**LEGAL ADVERTISEMENT
HISTORIC PRESERVATION BOARD
CITY OF PORTLAND
Public comments are taken at all meetings.**

On **Wednesday, March 16, 2016** at **5:00** p.m., Room 209, 2nd Floor, City Hall, the Portland Historic Preservation Board will meet in Room 209, City Hall, to review the following items. (Public comments will be taken at this meeting):

CITY OF PORTLAND, MAINE
HISTORIC PRESERVATION BOARD

HISTORIC PRESERVATION BOARD AGENDA

A-2.1

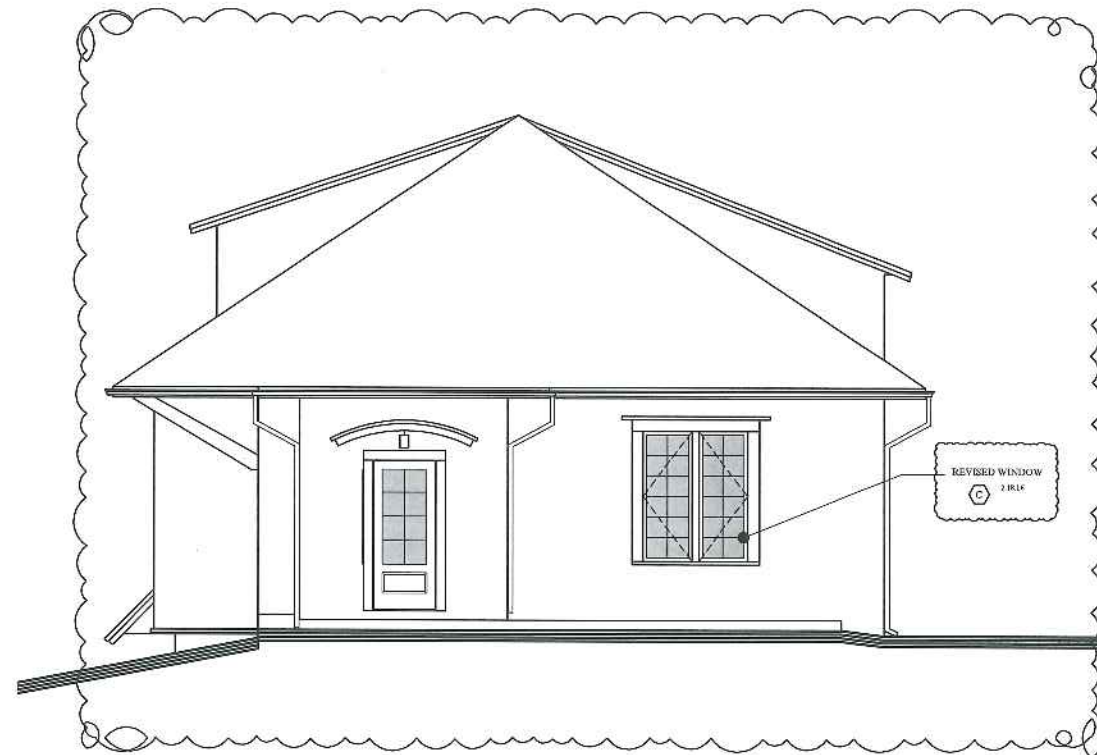
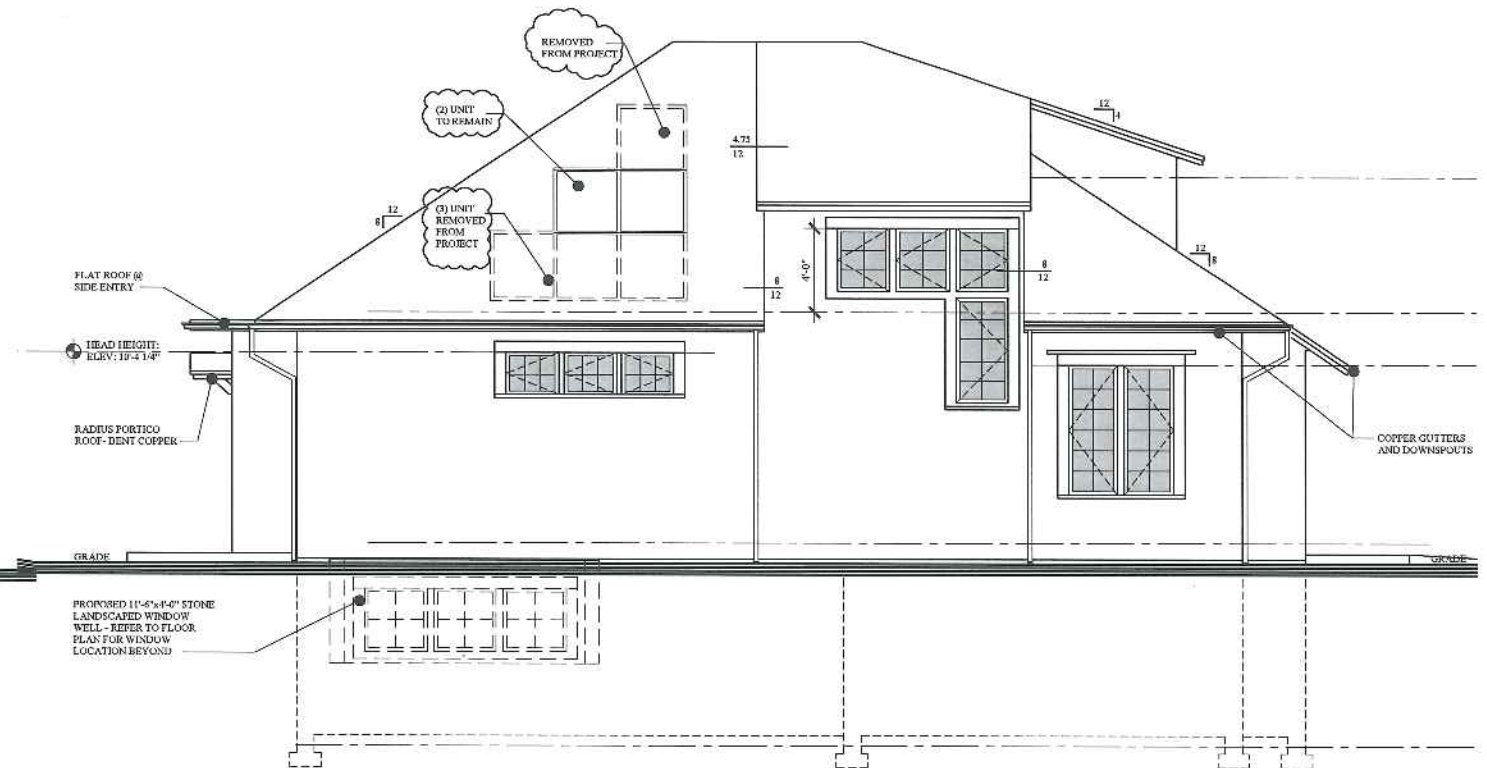
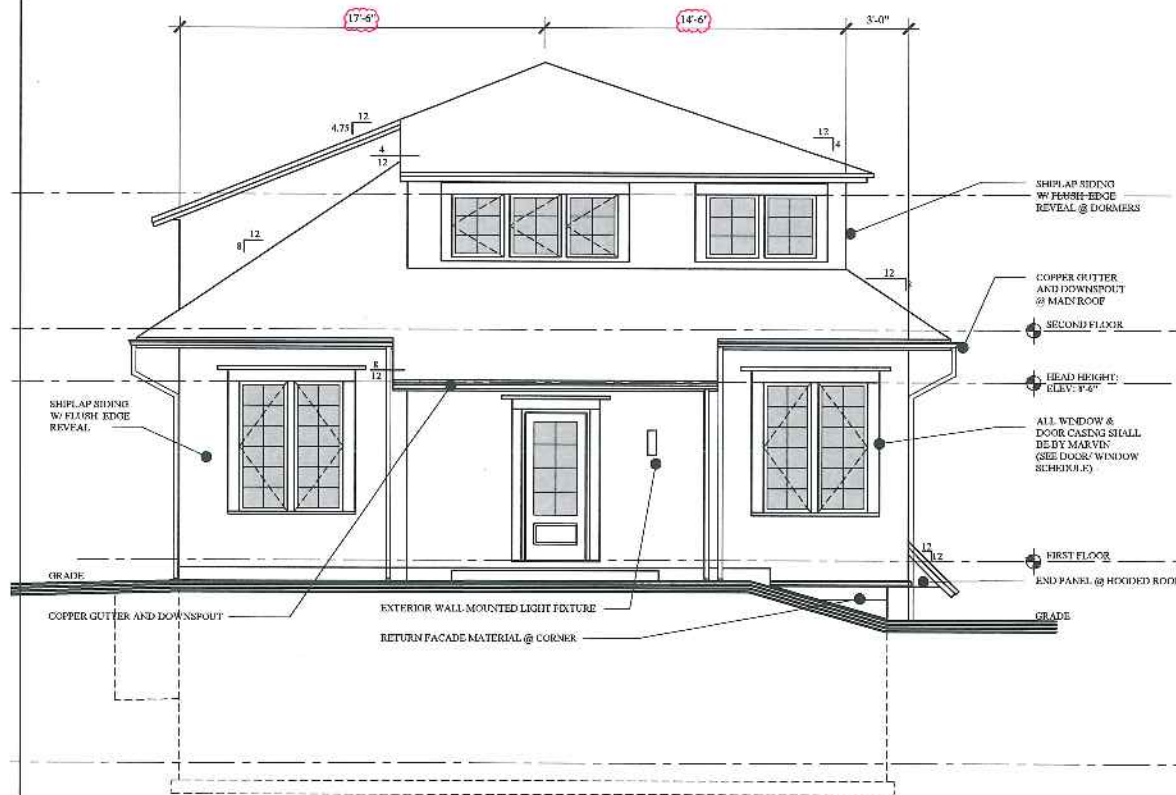
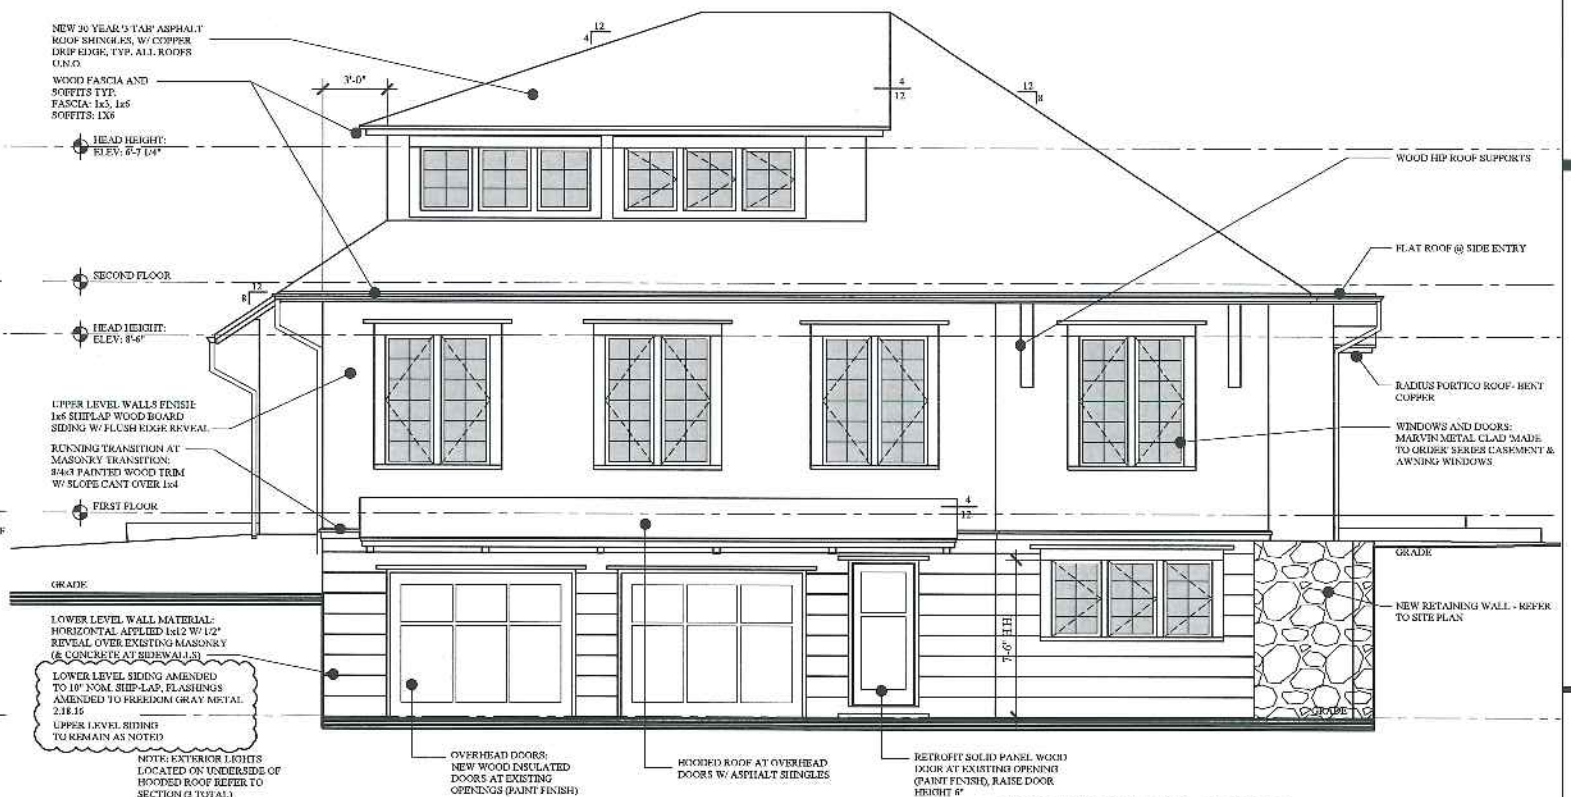
Mr. Mueller's amended drawings include highlighted bubbles to mark the plan changes – most notably:

- The height of the ridge above finished first floor is unchanged, and the actual average roof elevation is 169.76'
- In response to the higher floor height, site grading will be higher in places

- In keeping with higher grades, the top of the retaining wall in the left (west) side yard is proposed to be at 142.5' – just over one foot higher than on the approved site plan

- It appears possible that the slope toward the west property line (in left side yard) is proposed to be slightly steeper than originally projected
- In the stairway from the driveway into the left side yard and secondary entrance, two steps (one in the upper section, and one in the lowest section of stairs) will be added

In considering the requested amendment to the previously-approved plans, the Board will need to evaluate the various ramifications of the higher than expected finished floor elevation. Because the site (and main floor of the house) is already elevated above the street, and above the property immediately to the west (21 Orchard Street,) the Board must examine whether the new height can be absorbed by the proposed site changes without adversely affecting the relationship of the house with the site and its surroundings. Questions for consideration include:

- Would it be preferable to absorb the added height close to the house, outside the west secondary entrance, and in so doing return quickly to the intended grading as originally approved, or would this approach call more attention to the elevation of the house in relation to the site?

Regarding the proposed changes to the house itself, staff is of the opinion that the modifications do not materially affect the design as originally approved.

- The proposed change to the siding on the lower walls should not greatly alter the appearance.
- The window and skylight changes on the east will simplify the elevation and enhance cohesion of this face.
- The changes to the skylights in the north roof will not be visible from Orchard Street, and solidify the roof plane.

Image showing distance between two homes and elevation difference.
Region between fence and edge of 11 Orchard Street is the 14' set back from the property line.
Any entryway landing would be built into this space.

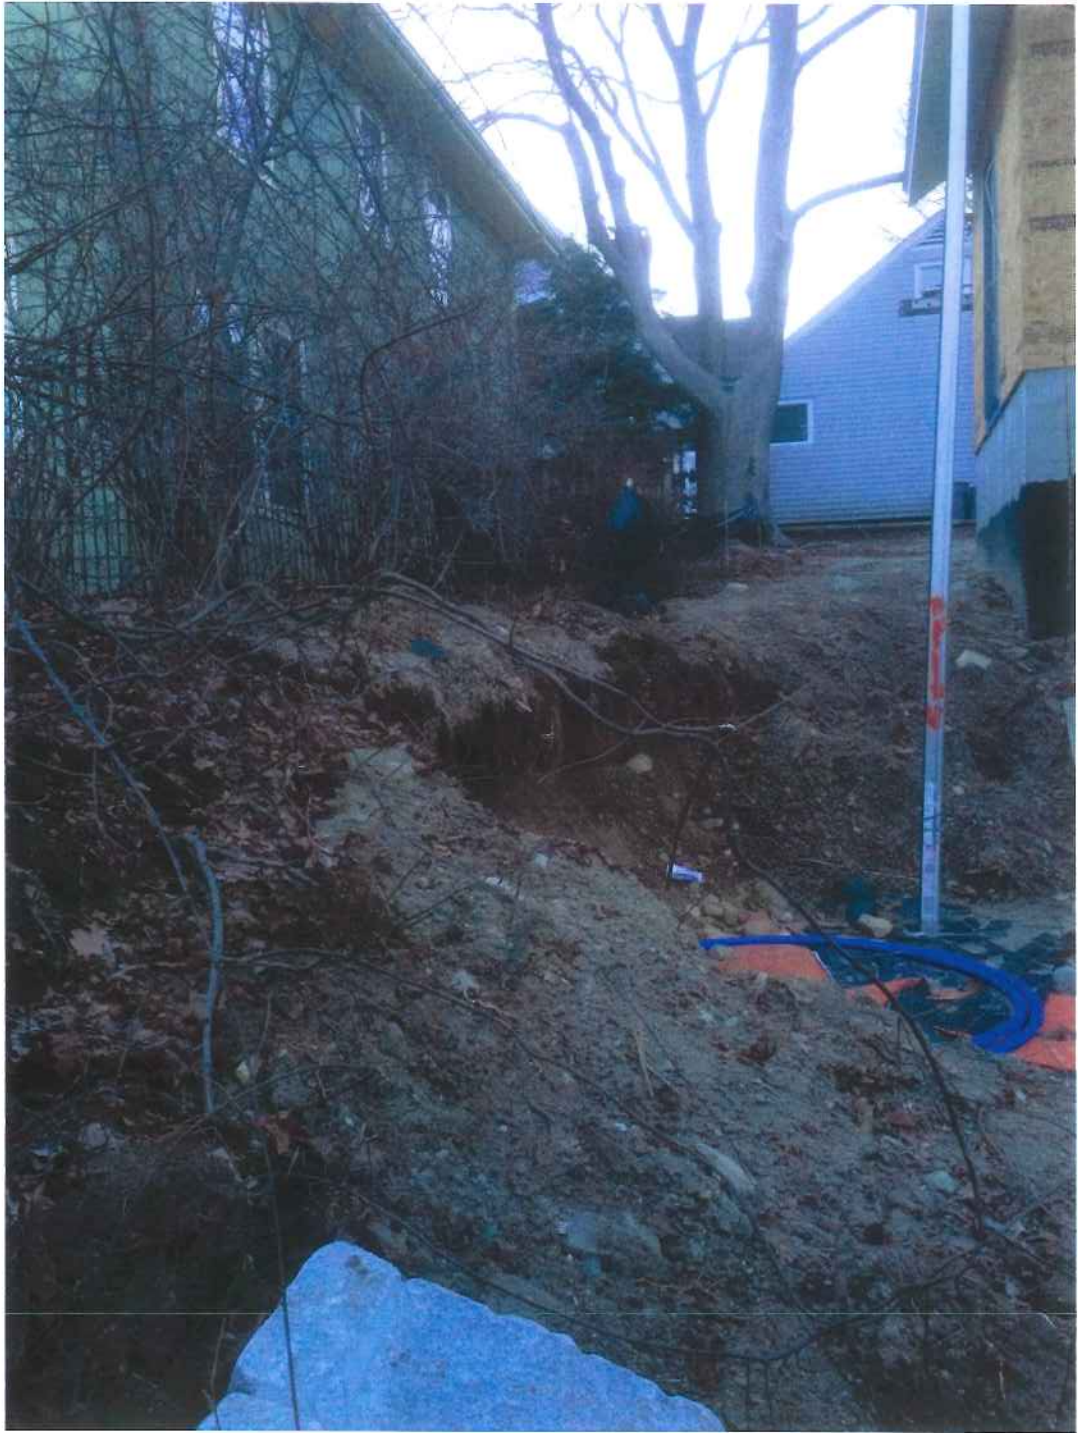
I have provided pictures of the present building of the left side of the home from the street and from the back. You will note the high vertical change in gradient required for any proposed entry on the left side of the home.
